RECEIPT DATE: 8-8-22 ONSITE SEWAGE DISPOSAL SYSTEM P 572129

PROPERTY ADDRESS: 7012 Colt Place

SUBDIVISION: Willowshire LOT: 29 TAX ID:

The BAT/LPD Plan for 7012 Colt Place (Willowshire Lot 29) has been reviewed with the following comments:

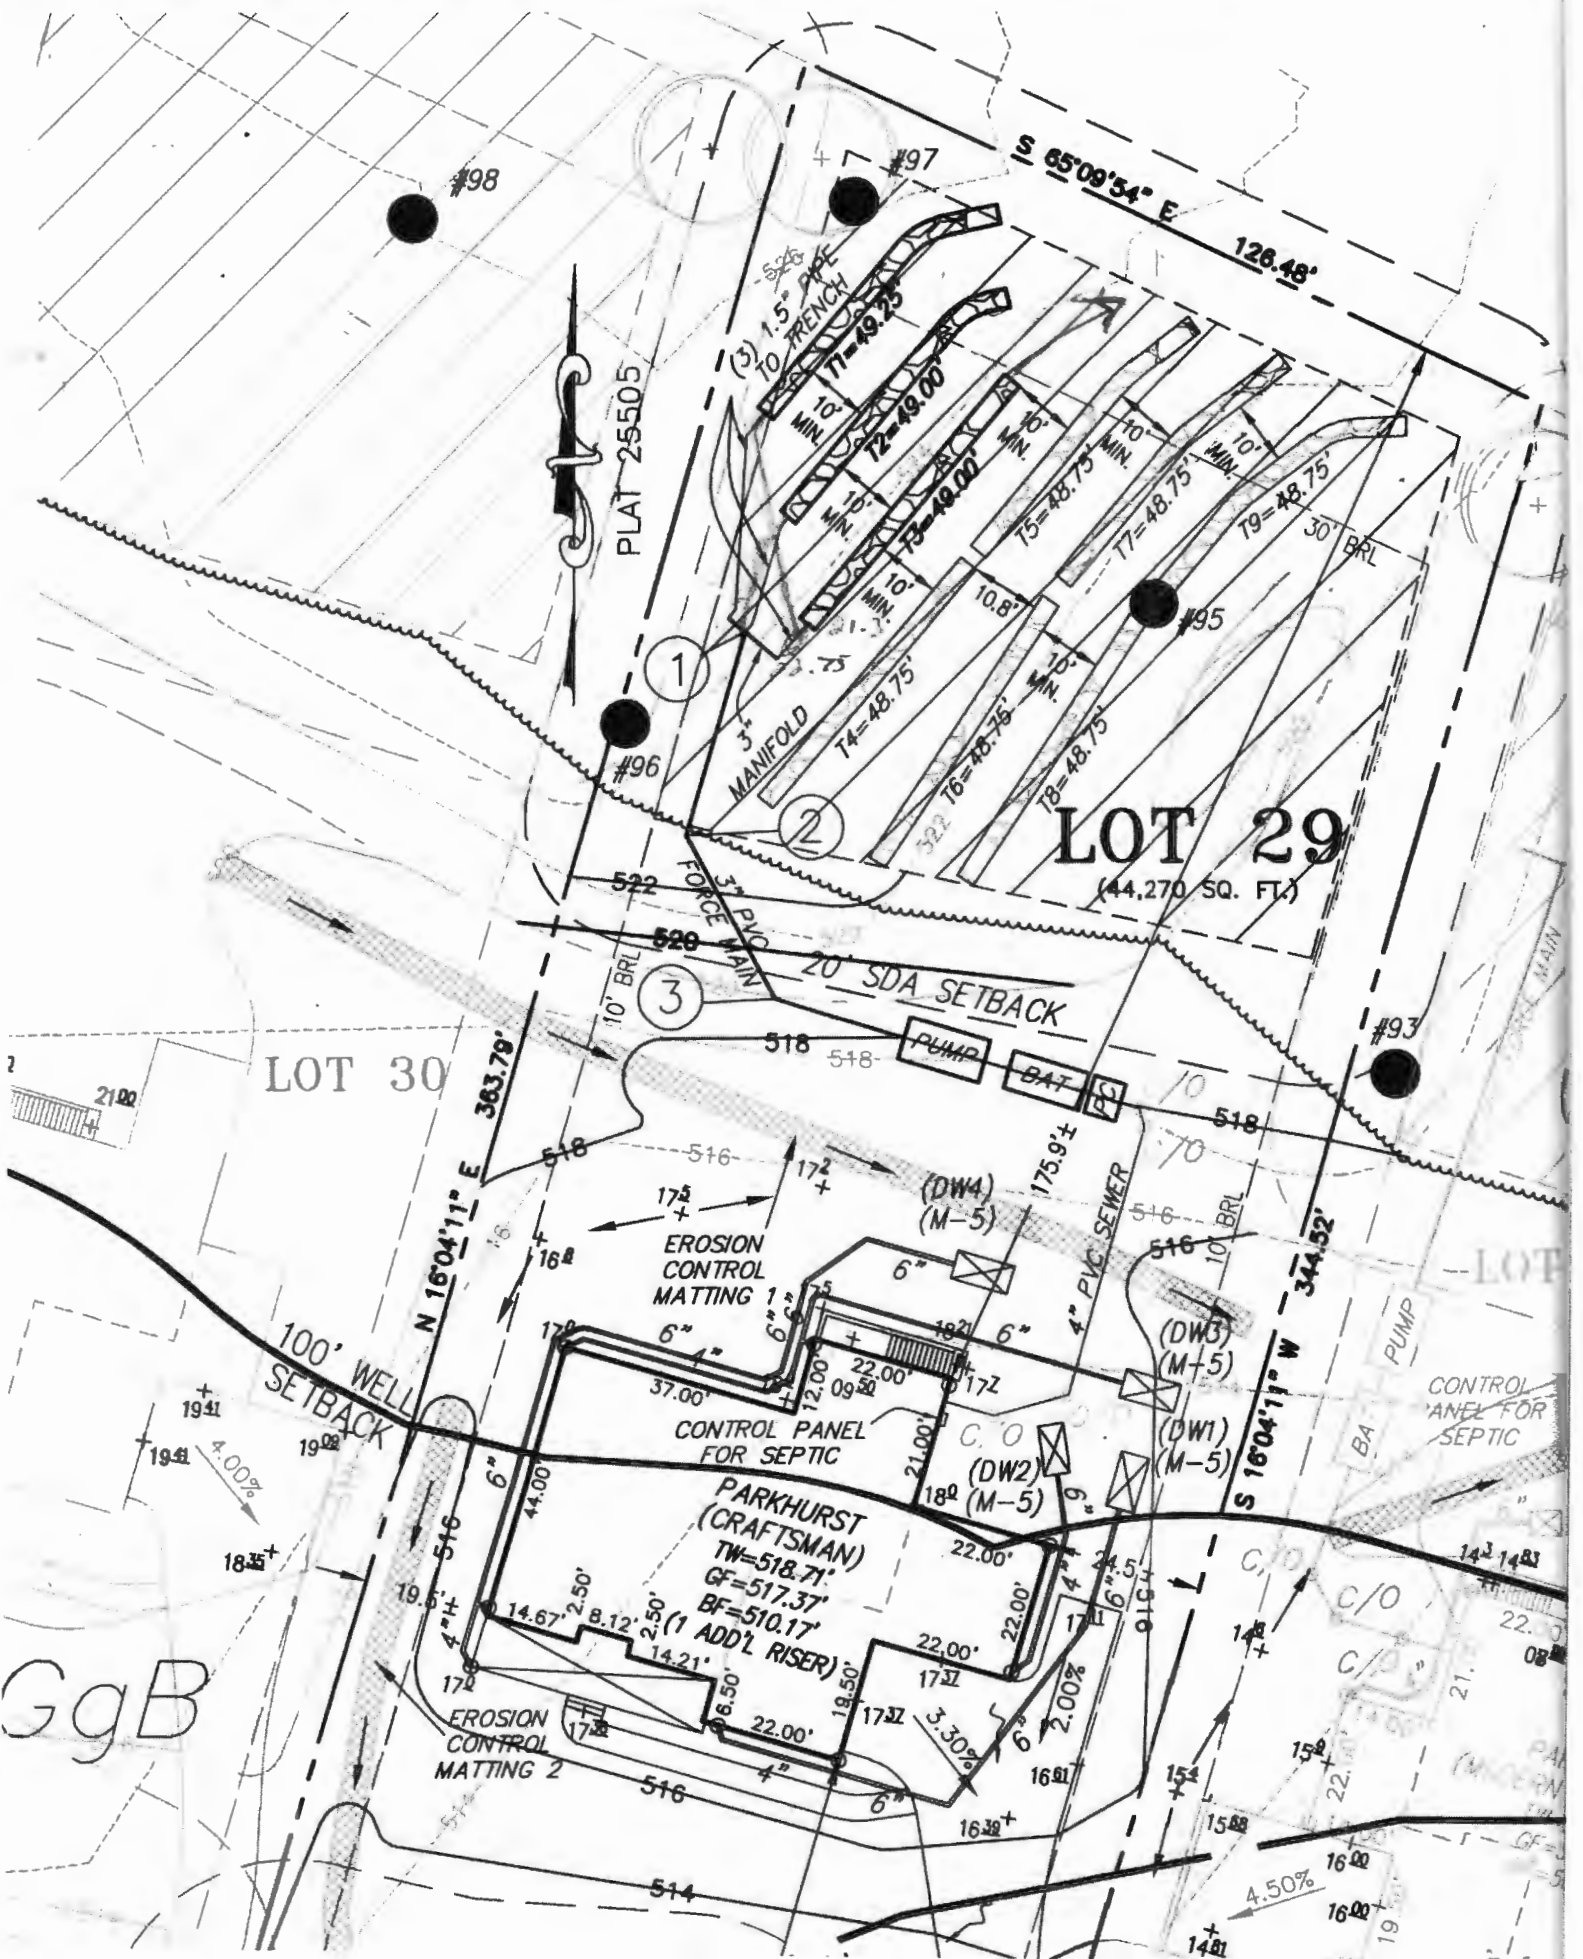
- DONE 1.) Move manifold and adjust lowest trench forward as shown. Manifold should be level. (see attachment)
- DONE 2.) Show manifold/lateral figure with elevations. When pumping uphill laterals should be higher than the manifold.
- ?? 3.) Show charts
- DONE 4.) Show drywell line elevation on septic profile. You don't have to show sleeve on septic line (only for well lines).
